**REQUEST FOR FURTHER INFORMATION #2 - PRIVATE PLAN CHANGE 29 -  
SUMMERSET VILLAGES (RANGIORA) LIMITED, 141 SOUTH BELT, RANGIORA**

We set out below in tabular form, a set of responses to each of the points you raised in your letter:

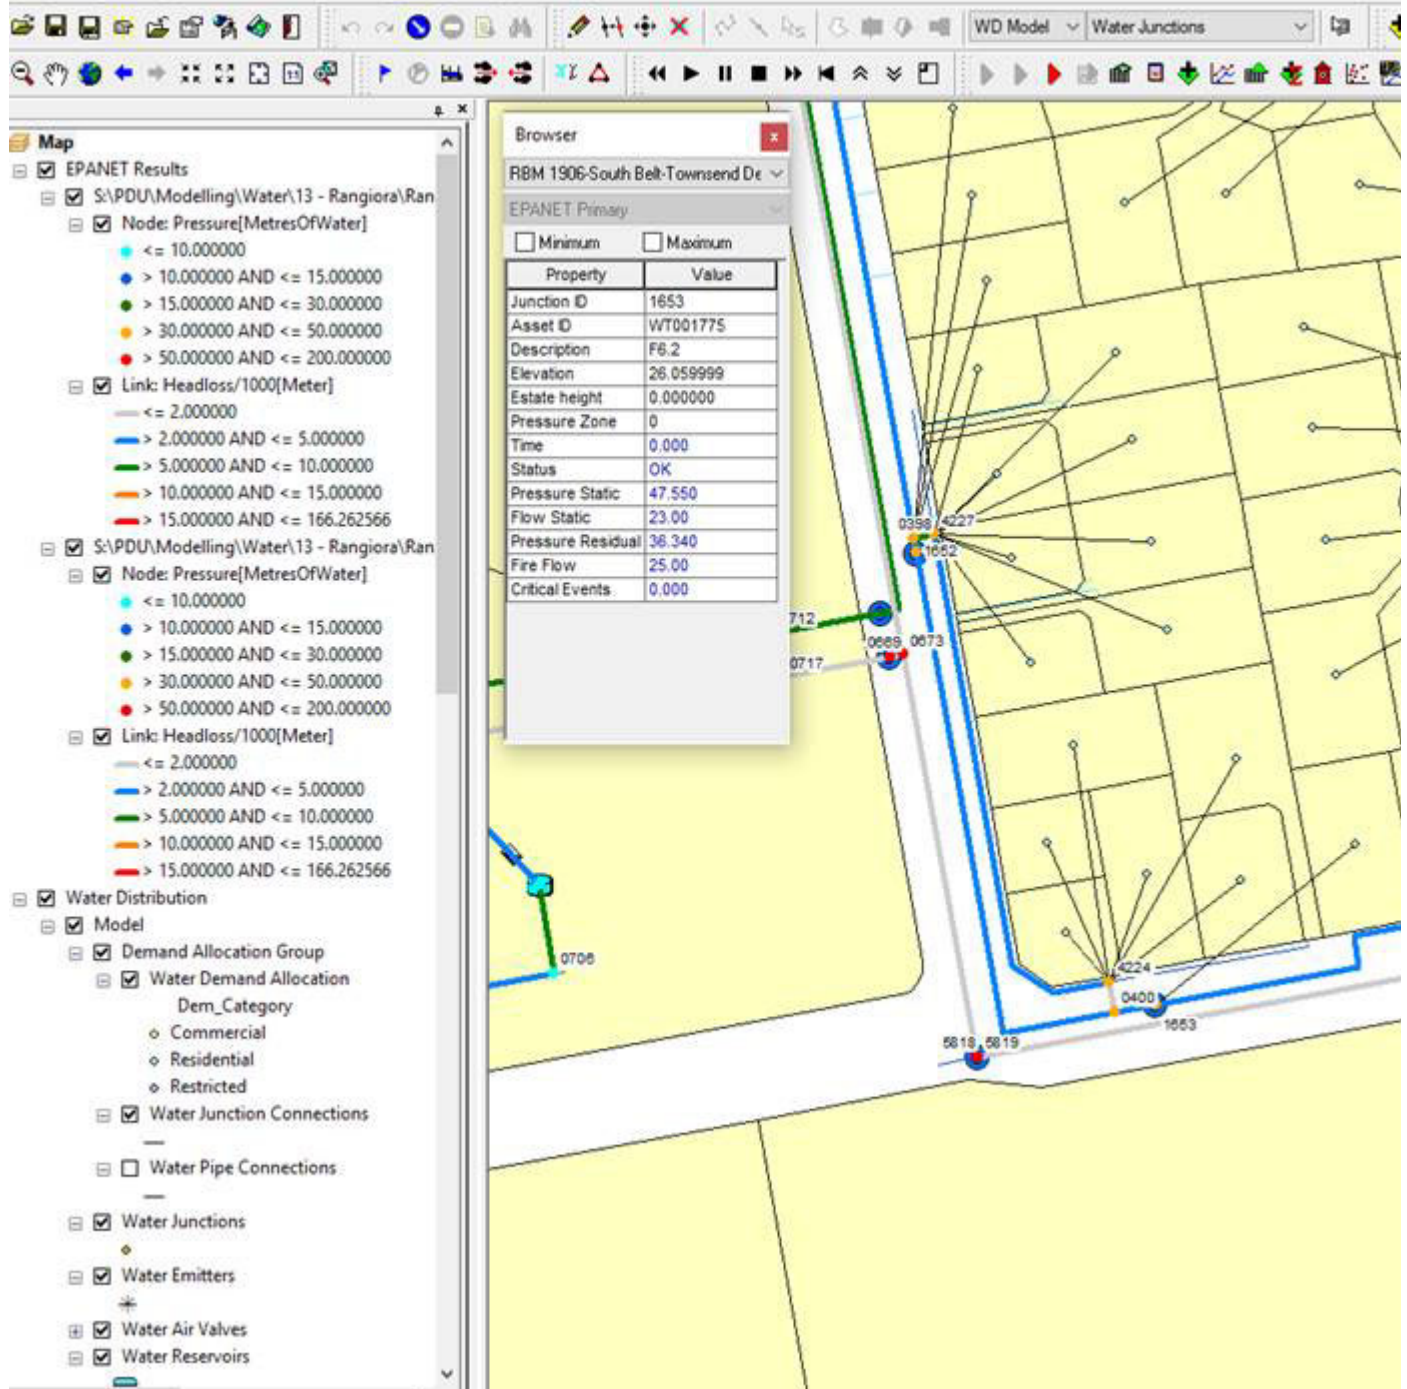
**From:** Harriette Davies  
**Sent:** Wednesday, 31 July 2019 11:31 AM  
**To:** Chris Bacon  
**Cc:** Gary Stevenson  
**Subject:** RE: 104 Townsend Road & 141 South Belt, Rangiora

As discussed the model doesn't indicate any issues with an additional 22.2 L/s PHF on one connection off the 150 PVC main. We are still maintaining approx. 48m of pressure at peak time.

There are also no issues with the firefighting flow (Assuming 25L/s and 50% PHF). There is approx. 36m of residual pressure at that location. Refer to results below.

So Gary, we modelled a worst case scenario (ie all the demand off one connection point on the existing 150 main and we didn't encounter any issues with the model meeting our normal LOS requirements.

Therefore we don't need to be concerned about capacity, it'll more be a question of redundancy and whether we need two feeds to the retirement village and/or the residential area to maintain that redundancy.

Also we don't need to connect into the 300mm dia pipe. We can connect one or more connections to the 150mm dia pipe without any problems.

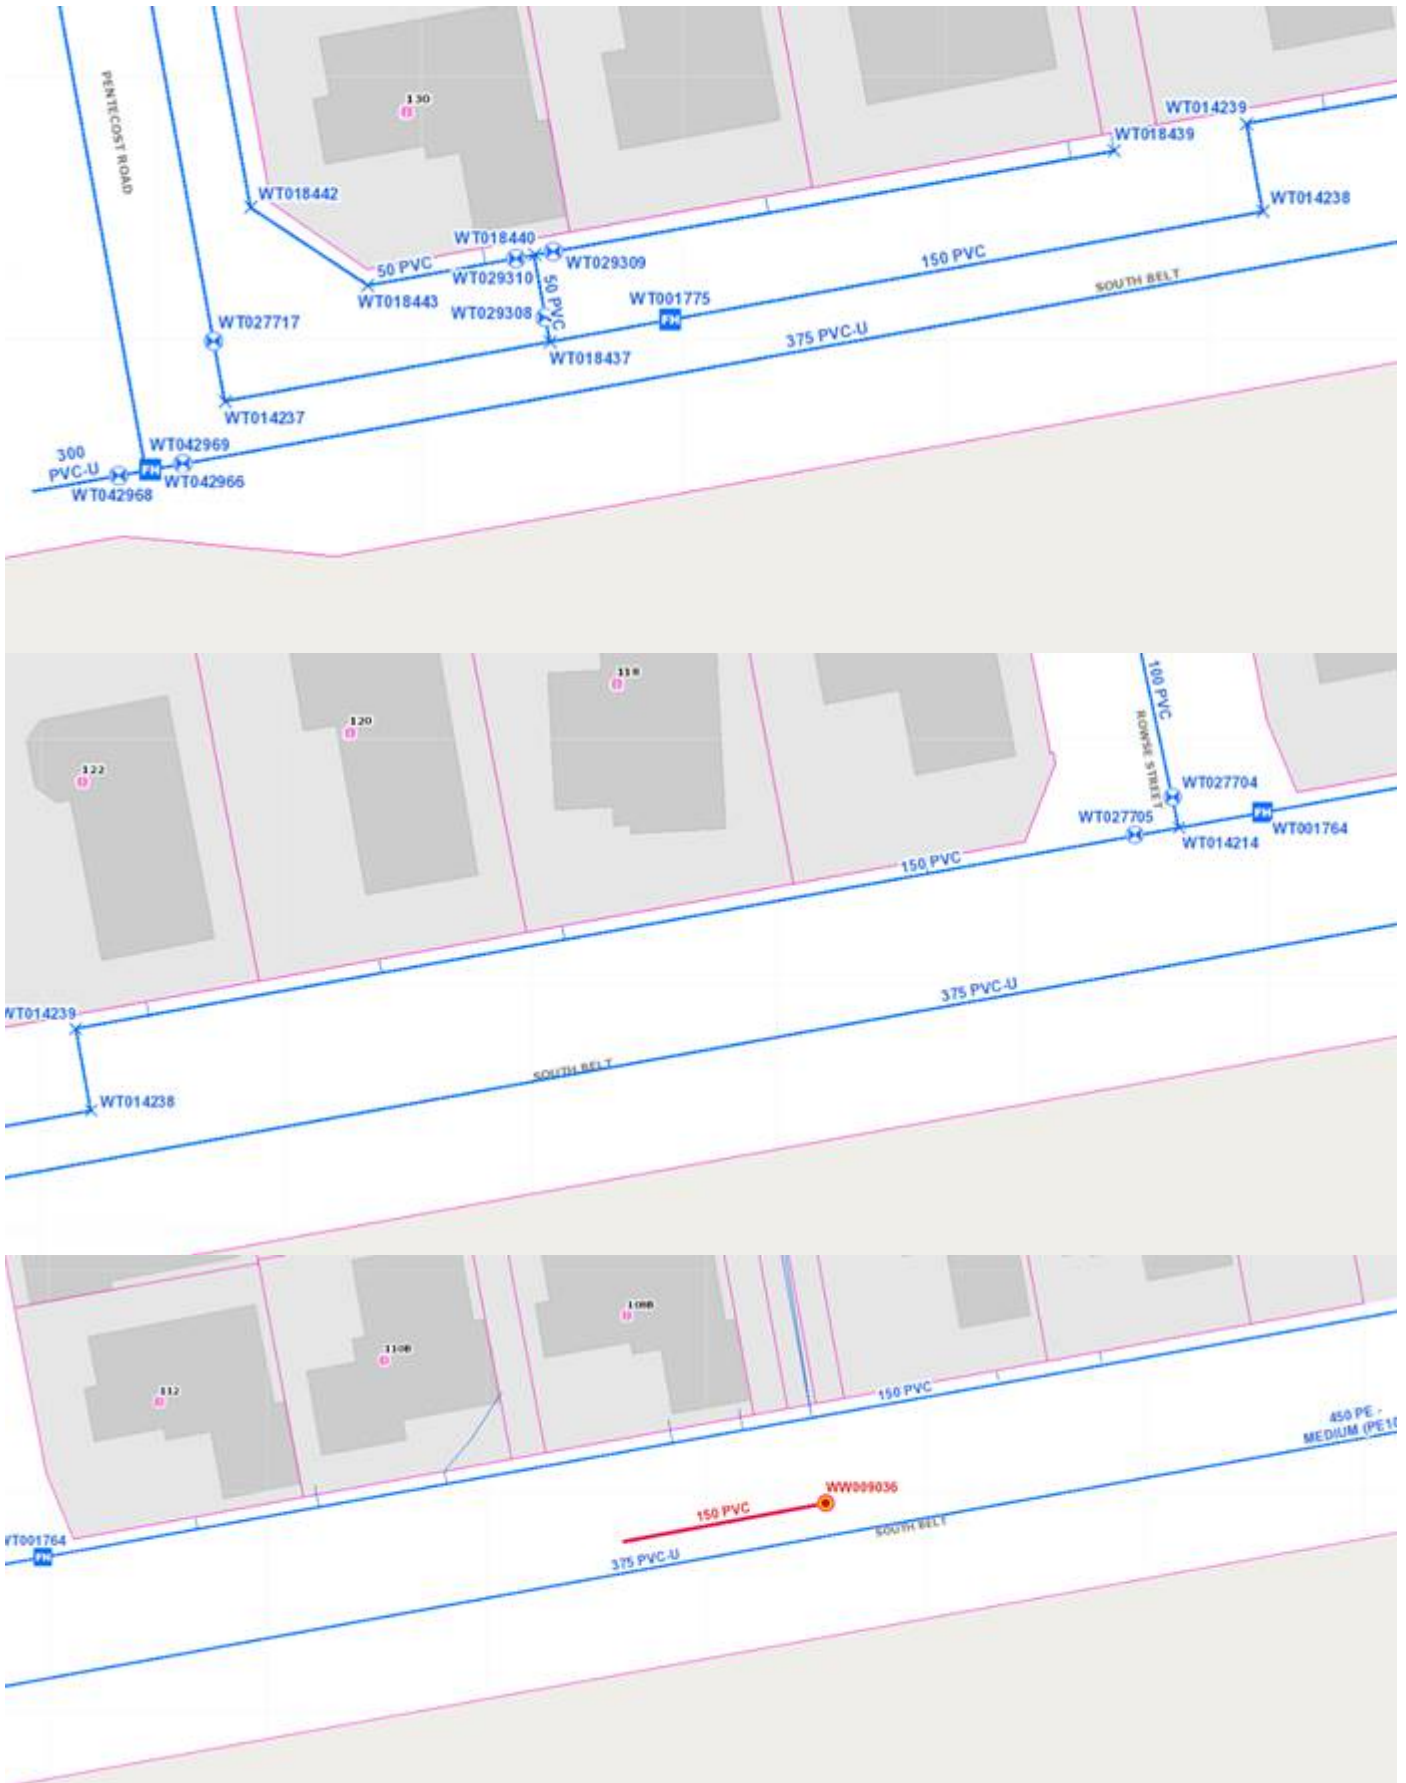
See attached for possible connection locations:

\* the above is potable demands only, an additional 25L/s for fire fighting flows would need to be included.

We have not got to the point of modelling yet, therefore cant confirm demand splits. At present we are trying to gauge when/if this upgrade would be required.

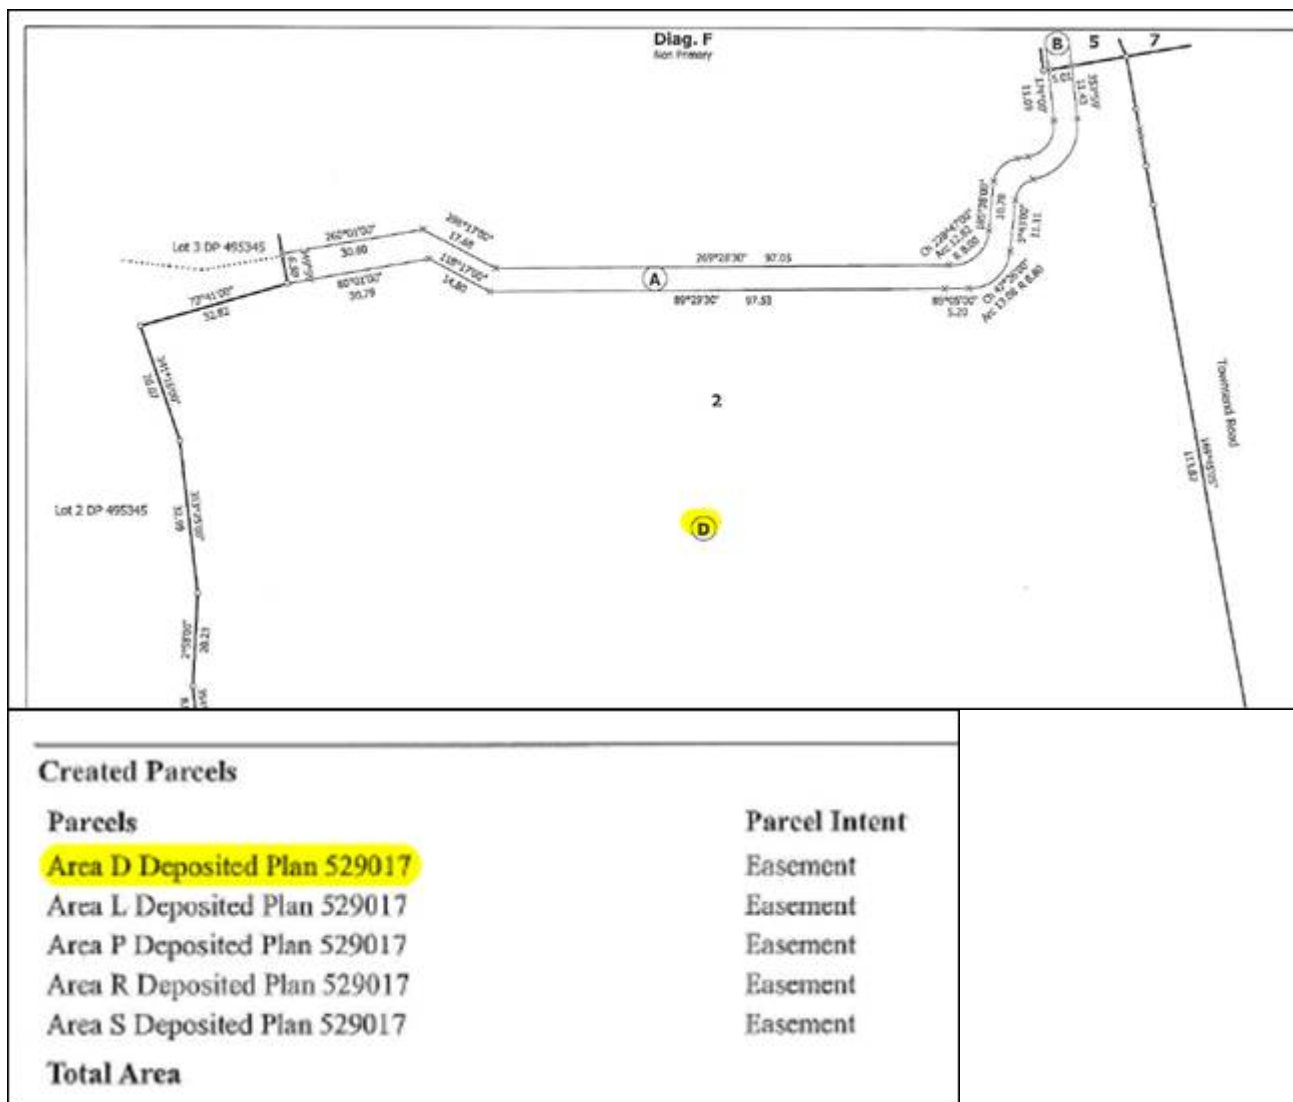
1. The **Dataset Description** includes Lot 11, however, a Lot 11 is not being created by the subdivision.

This has been amended and the reference to Lot 11 has been removed.

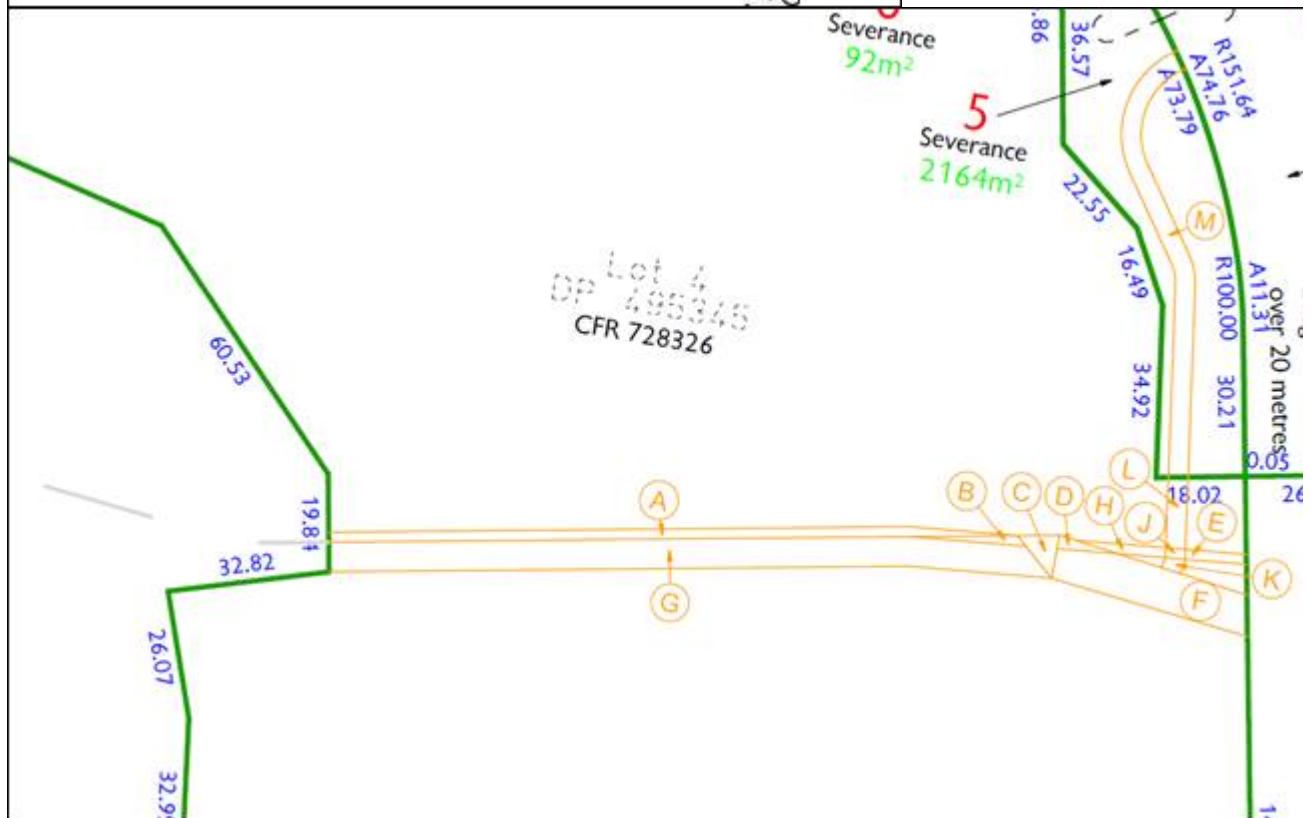
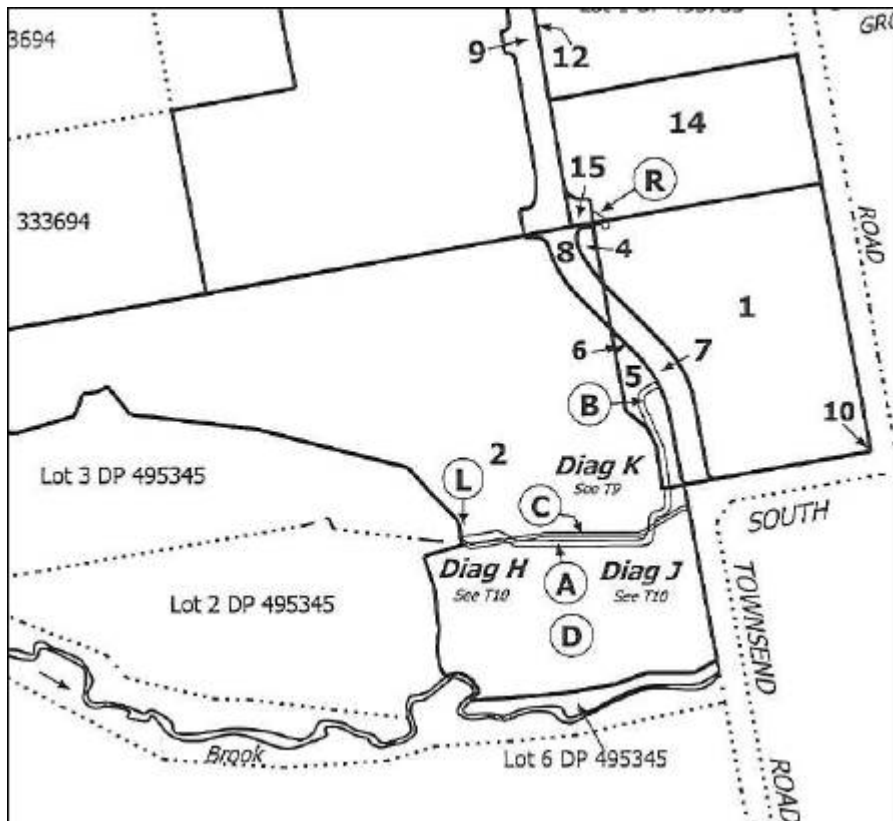
6. Not all easements are shown on all diagrams, for example Easement C is not included on Diagram F, can you please advise if this is standard practice?

Easements C and L has been captured as a tertiary easement to simply the easement layout, and avoid having to split the easement into 8 parts. I have amended the diagrams to show both the secondary and tertiary easements so the relationship between the easements can be seen.
